<b>Service Bulletin</b> <b>New Lever Handle</b>	
<b>Release Date: Nov. 20. 2014</b>	<b>Models Affected:</b>	<b>Bulletin Number</b>
<b>Prepared by: Stefan Seise, Michael Donhauser, Gabriel Arranz</b>	<b>Tomahawk S-Series &amp; IC3 powered by ICG</b> <b>Matrix S-Series &amp; IC3 powered by ICG</b>	<b>SB-007</b>

Old design	New design	Different
		From long shape to round shape

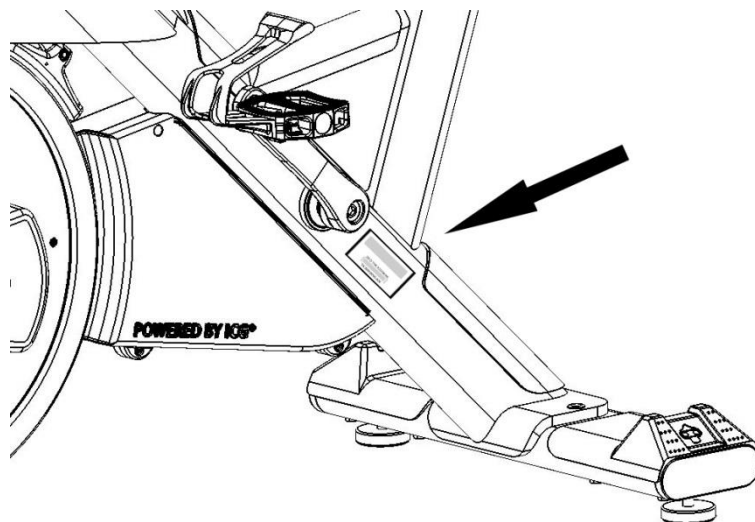
- Lever handle breaks after applying too much force to the lever.

- Size of the lever handle allows the user to apply too much force to the lever handle, breaking the plastic handle.

- Changing the form of the lever handle, so the user can't apply too much force when adjusting HB & SP sliders.

- 180-01-00002-02 LOCK HANDLE ASSEMBLY

### 3) New lever handle assembly

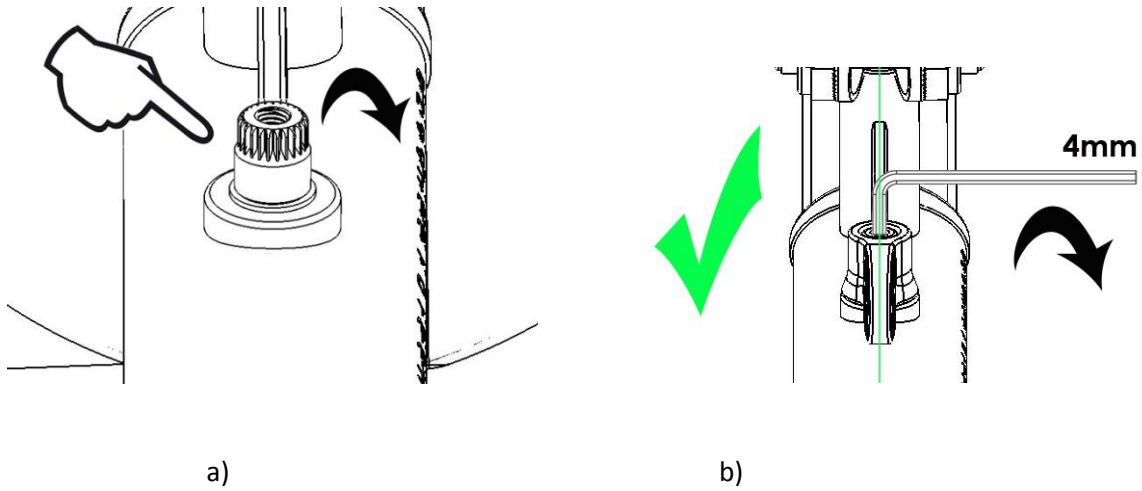
- a) Place the washer between upper seat post slider and adjustment bolt. Screw the new adjustment bolt in by hand.

- b) Place the new lock handle onto the adjustment bolt, turn until final close position is reached, reposition the lock handle and tighten the upper bolt using the 4mm Allen key.
